# Access Compliance Report

## Public Rights-of-Way

### (Curb Ramps)

Intersection ID: 52363	Main Street: DUNAVANT_ST	Cross Street: IRONSIDE_AV	Location: E
ADA ID: 7C8ACC38AA96	Ramp Type: Directional1	Initial Pass/Fail: Fail	Overall Compliance: No
		Severity Score: 12.5

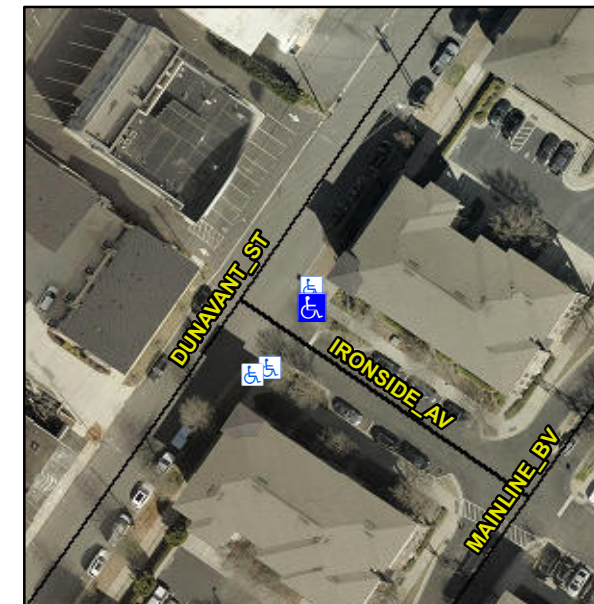
**R304.5.3**

Compliance	Description	Data	Compliance	Description	Data
N/A	Ramp Length (in)	82.0	N/A	Grade Break?	N/A
Yes	Ramp Width (in)	96.0	N/A	Grade Break Slope (%)	0.0
Yes	Ramp Slope (%)	7.3	N/A	Grade Break XSlope (%)	0.0
No	Ramp XSlope (%)	5.3			
N/A	Flare Type LT	N/A	N/A	Flare Type RT	N/A
N/A	Flare Slope LT (%)	N/A	N/A	Flare Slope RT (%)	0.0
N/A	Flare Traversable LT?	N/A	N/A	Flare Traversable RT?	N/A
N/A	Landing Length (in)	0.0	N/A	DWS Provided?	N/A
N/A	Landing Width (in)	0.0	N/A	DWS Contrast?	N/A
N/A	Landing Slope (%)	0.0	N/A	DWS Length (in)	N/A
N/A	Landing X Slope (%)	0.0	N/A	DWS Full Width?	N/A
N/A	Landing Curb? (Y/N)	N/A	N/A	DWS Offset LT (in)	N/A
N/A	Shared Landing?	N/A	N/A	DWS Offset RT (in)	N/A
N/A	Gutter Ponding?	0.0	N/A	Gutter Slope (%)	N/A
N/A	Gutter Lip Ht (in)	0.0	N/A	Gutter X Slope (%)	N/A
N/A	Painted X Walk1?	No		Road Slope (%)	0.5
	X Walk 1 Direction	To SW		Road X Slope (%)	0.5
	X Walk 1 Width (in)	N/A		Clear Space?	N/A

X Walk 1 Slope (%)	0.5	N/A	Clear Space to XWalk (in)	N/A
	X Walk 1 X Slope (%)	0.5	N/A	Storm Grate/Utility Hazard?	N/A
N/A	Ramp inside XWalk1?	N/A		Storm Grate/Utility Type	
N/A	Any Obstructions?	N/A			N/A
	Obstruction Type		Yes	Surface Condition? (G/P)	Good
			N/A	Curb Slope (%)	5.7

**Remove & Replace Entire Ramp.**
